**Technical Service
Information Bulletin**

ECM CALIBRATION: SHIFT FEELING ENHANCEMENT

'02 – '03 ES 300 & '04 – '05 ES 330

TC004-03

**Calibration
Identification
Chart**

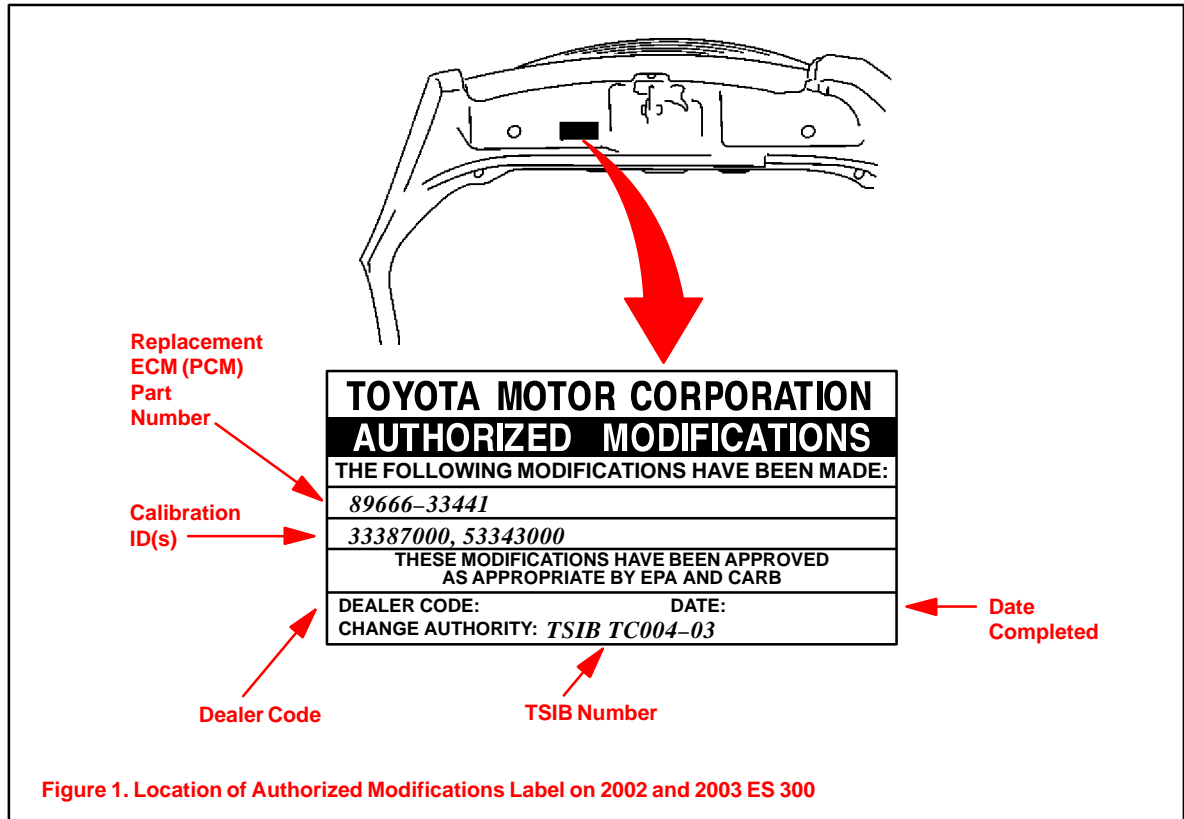
- If Calibration ID matches “Previous Calibration ID” as shown in Calibration Identification Chart on page 3, proceed with flash reprogramming.
- If Calibration ID matches “New Calibration ID” as shown in Calibration Identification Chart, this vehicle has already been programmed. Refer to TIS for diagnostic procedures applicable to any stored DTCs.

MODEL	ECM (CPU)	PREVIOUS CALIBRATION ID	NEW CALIBRATION ID
2002 – 2003 ES 300	Main	33323000	33387000
		33323100	
		33323200	
		33341000	
		33341100	
		33341200	
		33341300	
	33341400		
	Sub	53314000	53343000
		53314100	
		53314200	
		53328000	
		53328100	
		53328200	
53328300			
53328400			
2004 – 2005 ES 330	Main	33350000	33360200
		33350100	
		33360000	
		33360100	
	Sub	53334000	53340100
		53340000

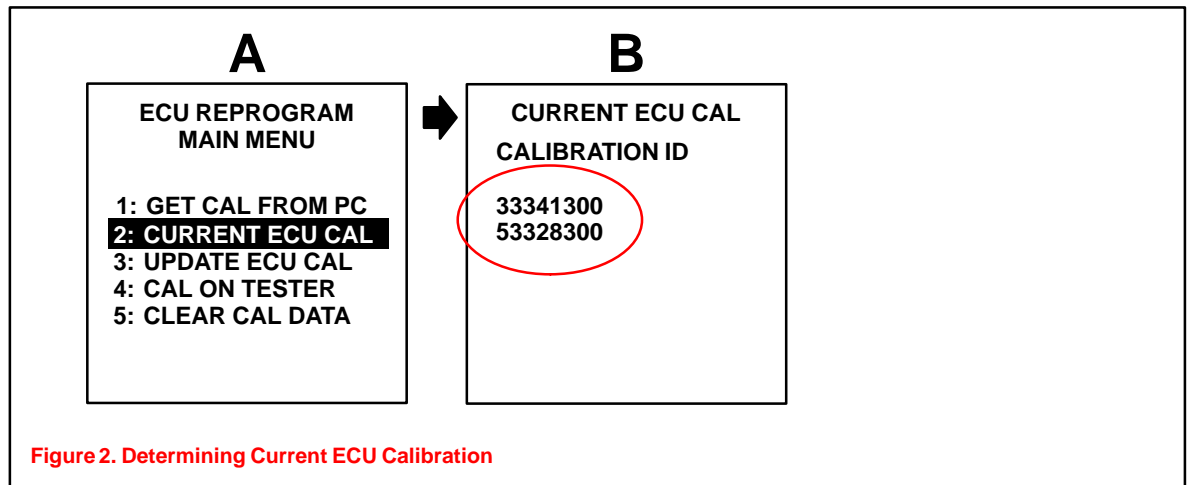
1. Check for the Authorized Modifications Label affixed to the vehicle in the location shown in Figure 1. Confirm if ECM (PCM) calibration has been updated. If not the latest ECM (PCM) calibration — go to step 2.

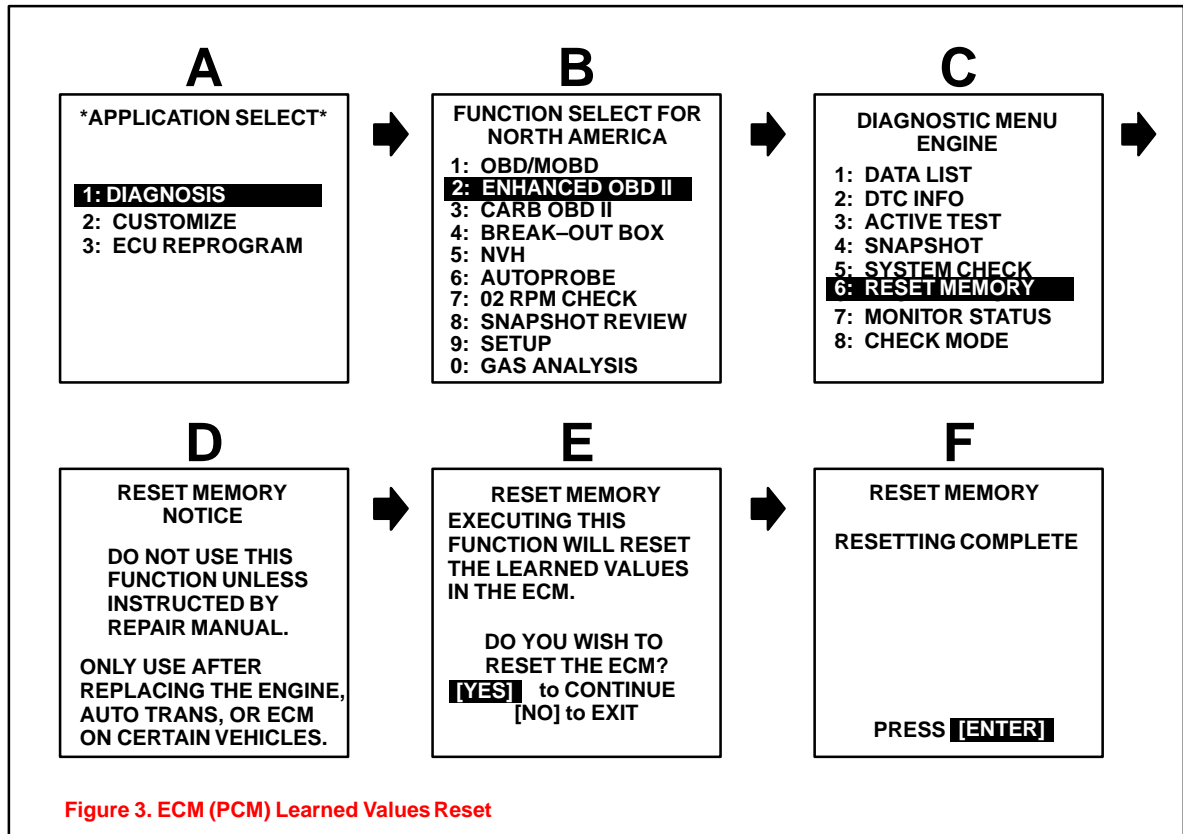
2. Connect the Diagnostic Tester to the vehicle and select CURRENT ECU CAL from the ECU REPROGRAM MAIN MENU. Determine the vehicle's current ECU calibration (see Figure 2).
 - The sample screen prints seen below are the 12.01a software version and may differ from subsequent software versions.

3. If ECU calibration ID is not the same as the “New Calibration ID” listed previously, proceed to Flash Reprogram ECM (PCM).
